Statesville Office (704) 878-5305 | Mooresville Office (704) 660-3625 | PERMIT # AP-303445

SEPTIC IMPROVEMENT PERMIT / AUTHORIZATION TO CONSTRUCT / OPERATION PERMIT / EXISTING SYSTEM

SOIL/SITE EVALUATION
for ON-SITE WASTEWATER SYSTEM
(Complete all fields in full)

Project name/owner
THE BLUE JAY
PARKERTOWN LOT 3
418 PARKERTOWN RD
MOORESVILLE, NC 28117

SEPTIC AREA

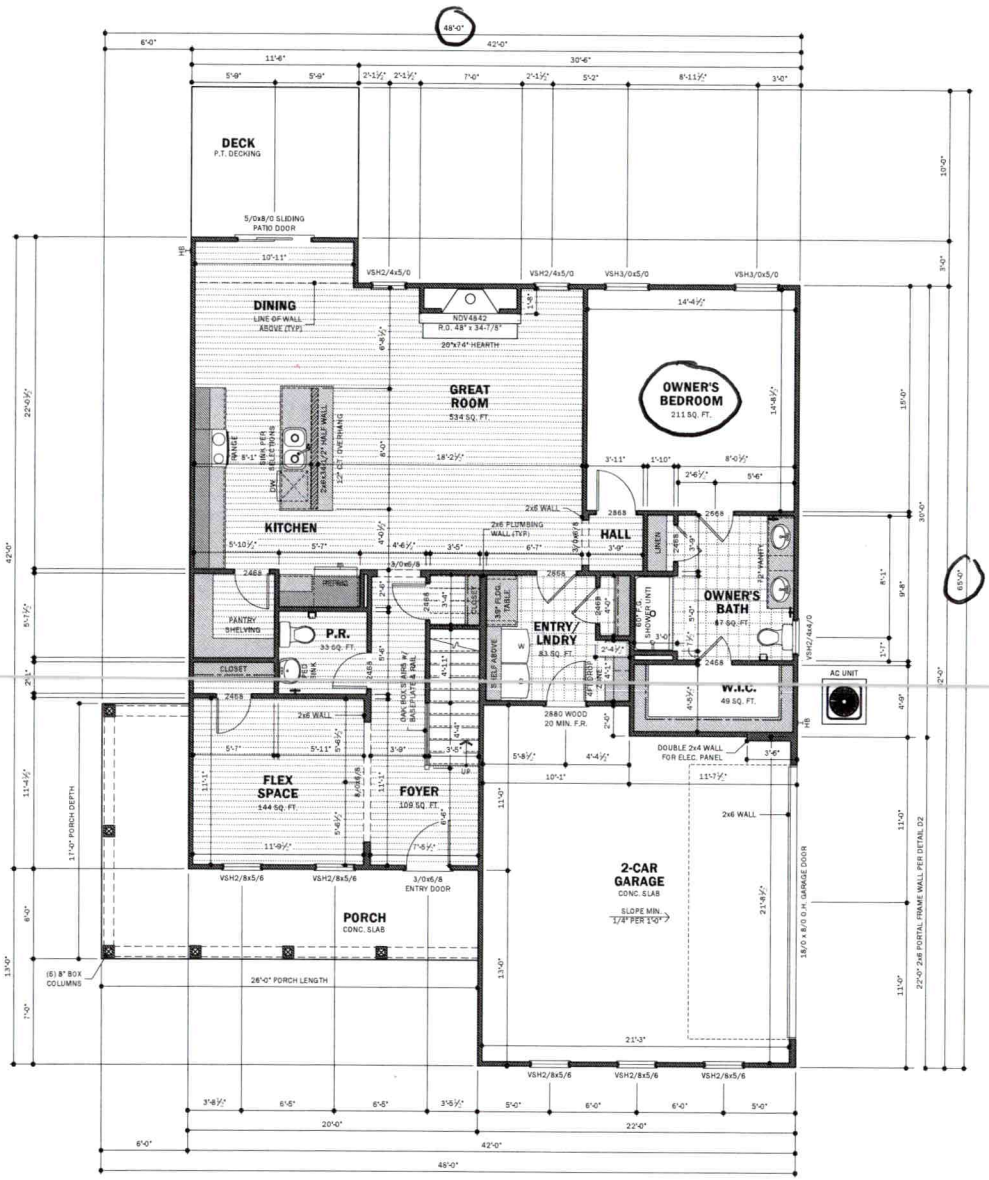
Dashed yellow line indica 10 'property line set k for septic lines

Move primary drain field lines towar rear property line as as possible
